STAFF REPORT
Docket No. WS-106-22
Summary No. 26272
Major Subdivision
Solarium Park

Subdivision of
 Lot C-3-B, Harvey Canal
 Property into
 46 lots, Solarium Park
 Subdivision, dedication of
 Solarium Loop and
 drainage servitudes

FIGURE 4

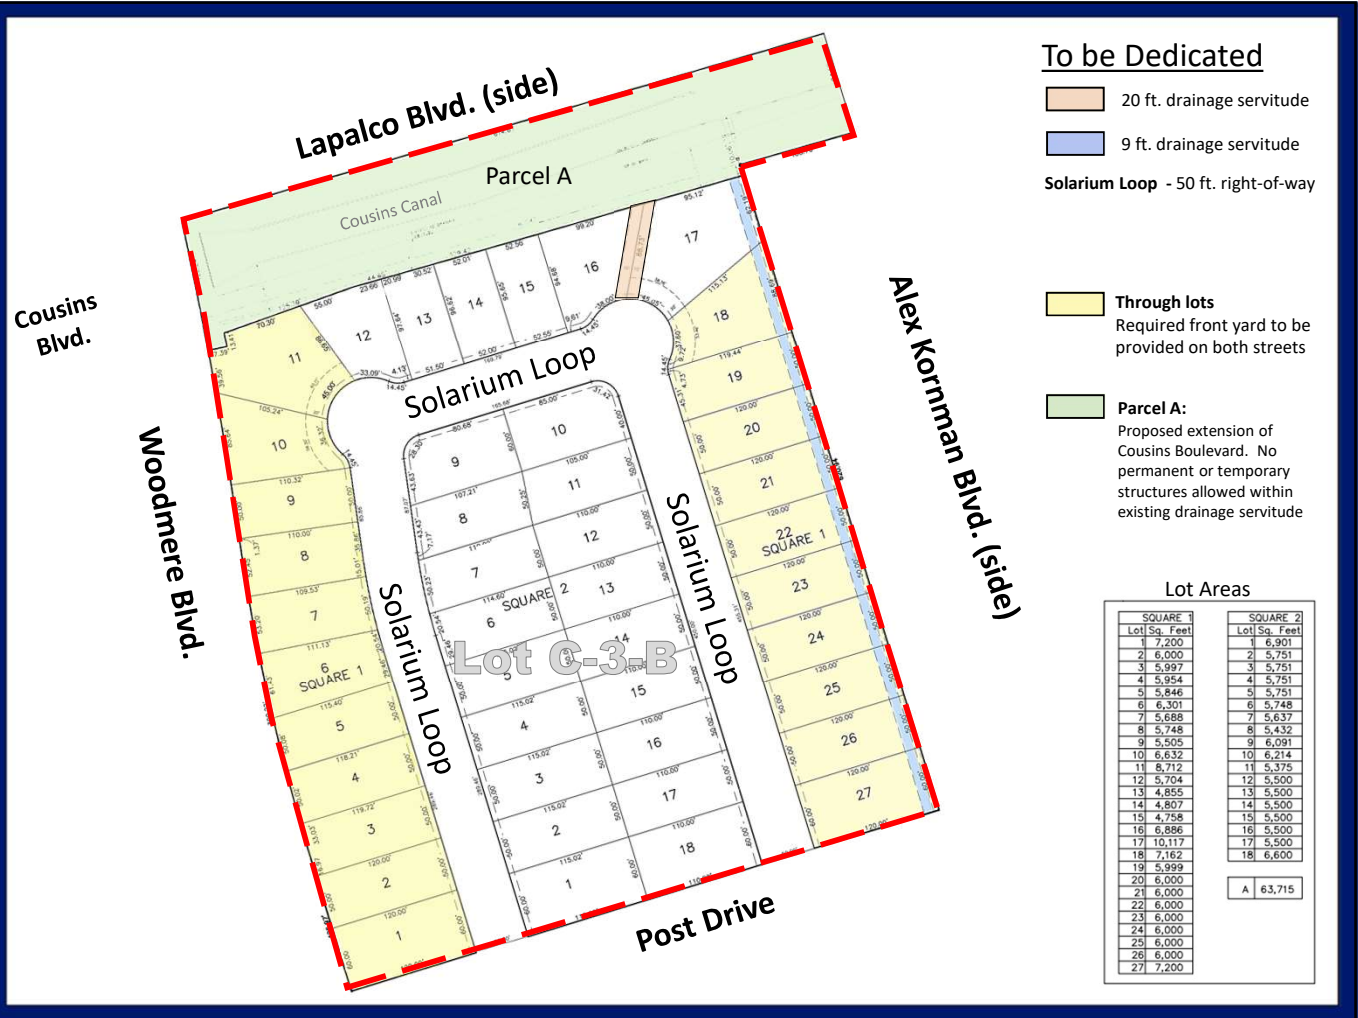
9. Proposed Lots 1 through 11, Square 1, Solarium Park, have frontage on Solarium Loop and Woodmere Blvd. Sec. 33-6.6.1 *Lots generally* states both lot frontages shall be front lines for setback purposes. As per the applicant, these lots will provide the required front yard on both streets. Additionally, lot access to and from Woodmere Blvd. will be prohibited.

Table 1: Land Use Review Technical Committee (LURTC) Comments		
Department	Position	Comment/Stipulation
Public Works		<p>WS-106-22 the Department of Public Works (on 10/06/2023) Drainage accepts the revised servitude width of additional 9 feet indicated on updated survey. All public sewer must be approved by the Engineering Dept. TIA is acceptable.</p> <ol style="list-style-type: none"> 1. Drainage Department states Drainage accepts the revised servitude width of additional 9 feet indicated on updated survey uploaded 08/22/2022. 2. Parkways has no comment, no landscape plan submitted. 3. Sewer Department states all public sewer must be approved by the Engineering Dept. No objections otherwise. 4. Streets Department has no objections. 5. Traffic Engineering Division states No objection. Sight triangle is not an issue at this time. TIA is acceptable. 6. PW Utilities has no comment. 7. Water Department no comment.

Through lots
Required front yard to be provided on both streets

Parcel A:
Proposed extension of Cousins Boulevard. No permanent or temporary structures allowed within existing drainage servitude

FIGURE 5

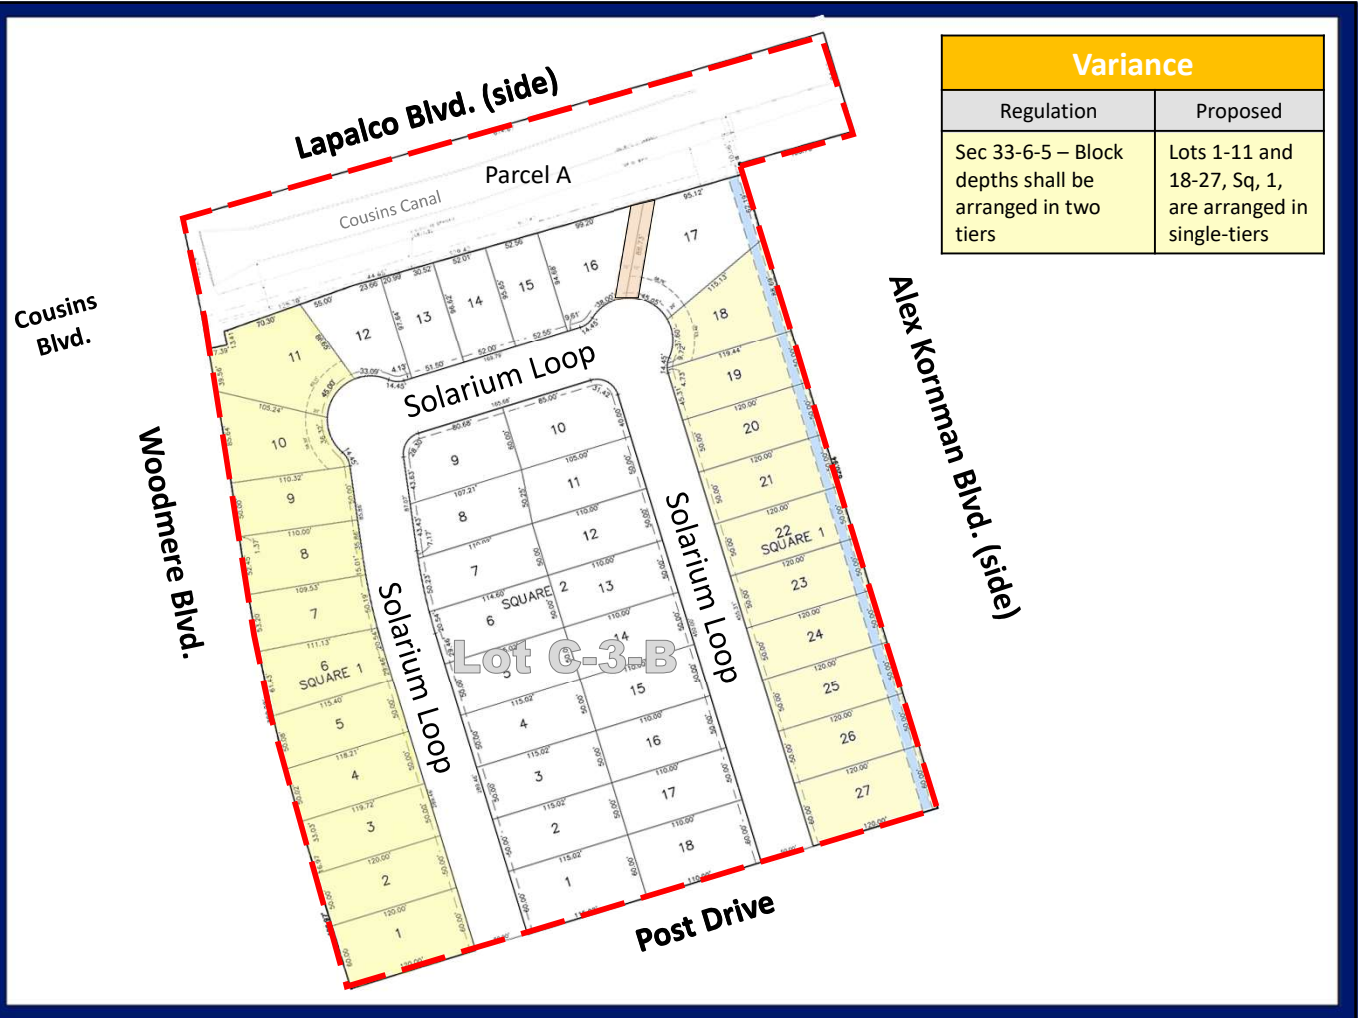
13. As per Sec. 33-6.5 *Block Standards* “the depth of the blocks shall be arranged to allow two (2) tiers of lots with utility servitudes, except where a single row of lots backs up to an interstate or arterial street, canal, river or railroad right-of-way.” The subdivision is designed with two (2) tiers of lots in the center with a single tier on the outer perimeter of the property. Proposed Lots 1 through 11, Square 1, back up to Woodmere Blvd. which categorized as a collector street and proposed Lots 18 through 27, Square 1, back up to abutting parcels; therefore, a waiver is required. With the exception of proposed Parcel A, which generally outlines Cousins Canal, existing Lot C-3-B has a square shape. The relative proportions of the existing lot, coupled with the minimum lot width and depth requirements, limit the potential block and lot pattern. Proposed Solarium Loop has a U-shaped design which incorporates a cross-street. The street has two (2) entrance and exit points allowing more evenly divided traffic flow within the proposed subdivision and onto Post Drive. The proposed block and lot pattern and street layout are consistent with the configuration of the existing lot; therefore, the requested waiver is appropriate. The findings outlined in Table 5 support the requested waiver.

Variance	
Regulation	Proposed
Sec 33-6-5 – Block depths shall be arranged in two tiers	Lots 1-11 and 18-27, Sq, 1, are arranged in single-tiers
